DRAWING RELEASE HISTORY		
TYPE	DATE	DESCRIPTION
ANCHOR ROD DRAWINGS	12-23-2008	PRELIMINARY FOR APPROVAL

Submittal Item: Anchor Bolt Plans  
 Comments

COVER SHEET

BUILDER	Broadmoor, LLC
CUSTOMER	John F. Stennis Space Center
LOCATION	Stennis Space Center, Mississippi
PROJECT	Riverine and Combatant Craft Operations Facility
BUILDERS P#

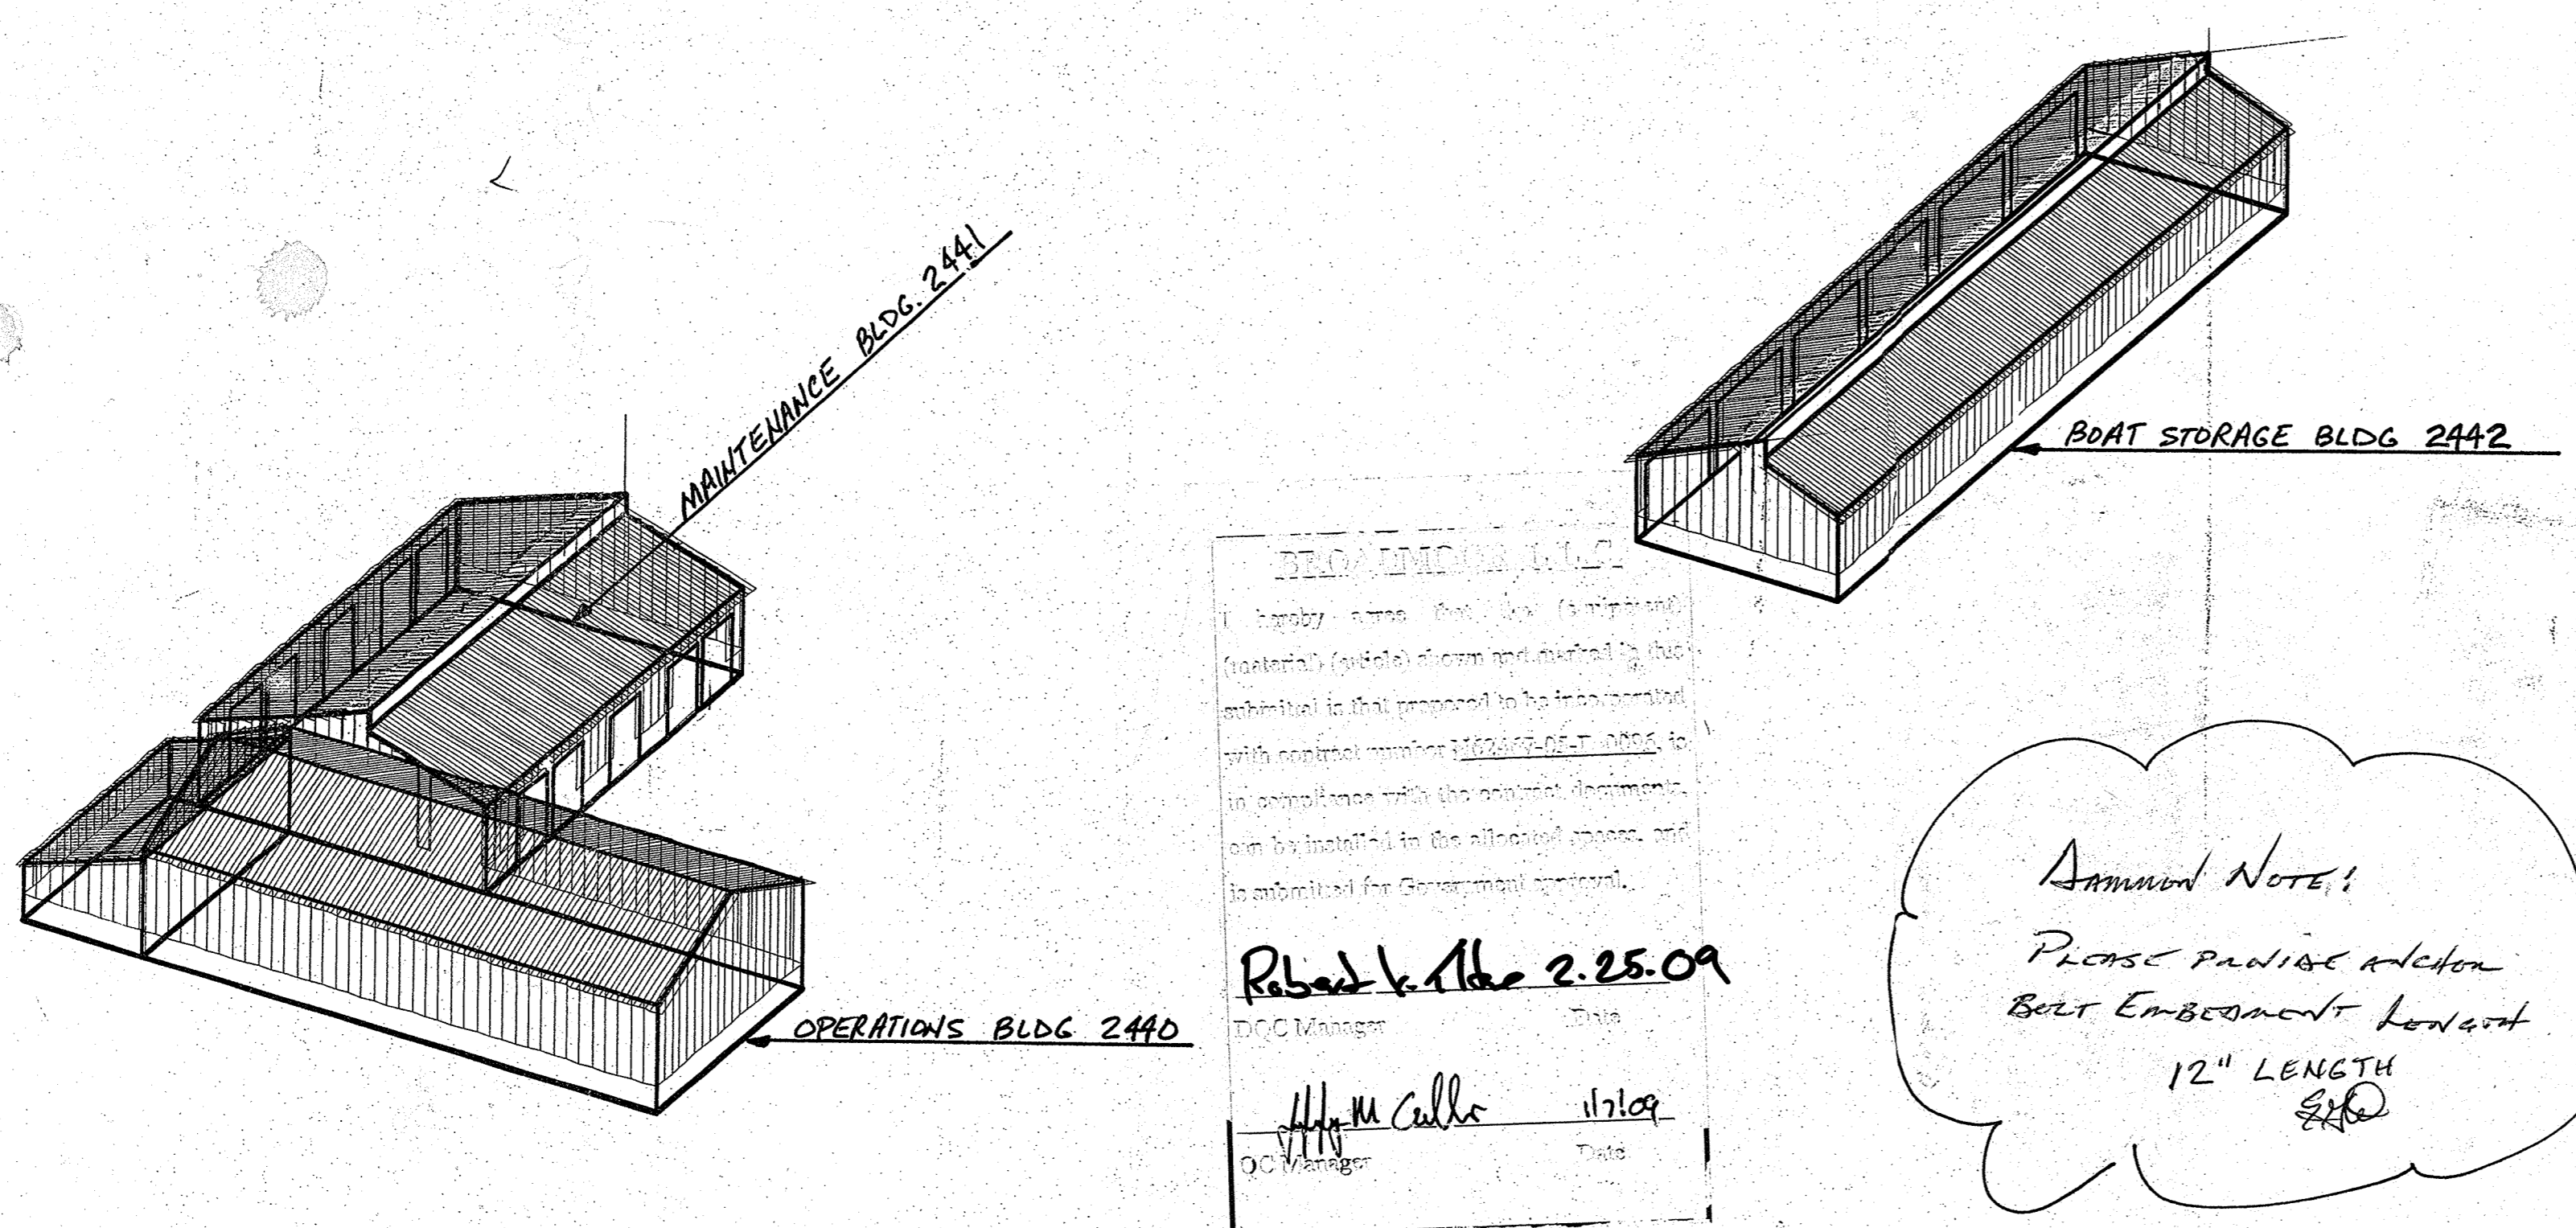
- Coordinate with subsequent drawings / submittals, especially rigid frame column / masonry wall dimensions.
